CONDITION OF CONCERN

On the driver seat of certain 2010-2011 Mazda3 and 2011 Mazda2 vehicles, the seat height adjustment lifter link may be cracked due to insufficient strength of the lifter link or the lifter link push nuts may be separated. If the vehicle continues to be used in this condition, the seat may exhibit an abnormal noise or rattling. In the worst case, the lifter link may be broken or detached from the seat frame, causing the seat to be inclined and the driver may not be able to maintain an appropriate driving position, increasing the risk of a crash.¹

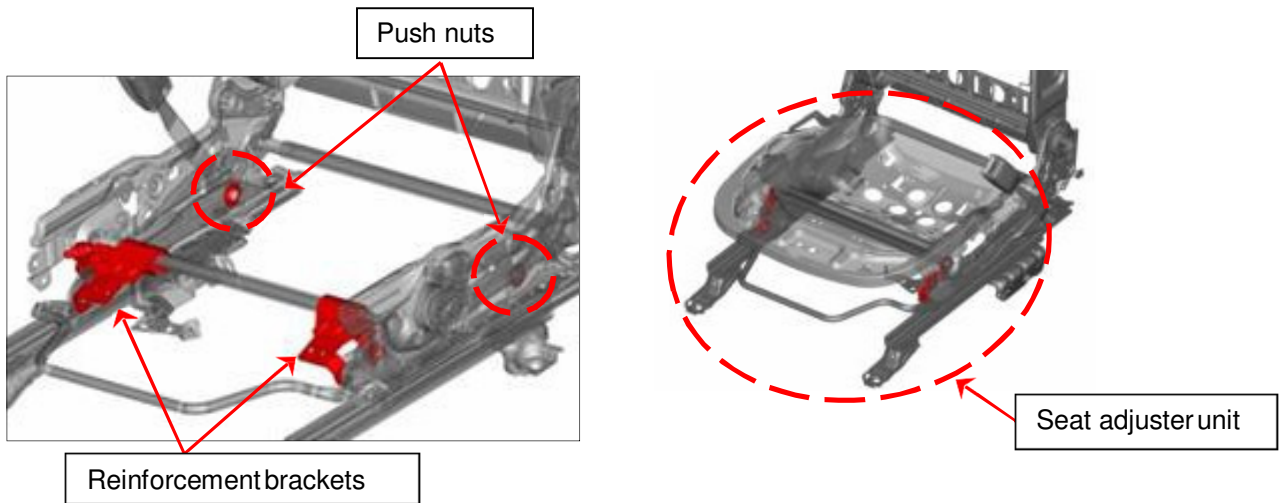
Dealers are instructed to inspect the front lifter links for any crack or damage, and if no crack or damage exists in the lifter links, install reinforcement brackets on the lifter links, and increase the number of push nuts for the rear seat lifter links to two per lifter link.

If any crack or damage exists in the lifter link, the seat adjuster unit needs to be replaced with a modified one. The inspection and repair must be performed on all subject vehicles at no charge to the vehicle owners.
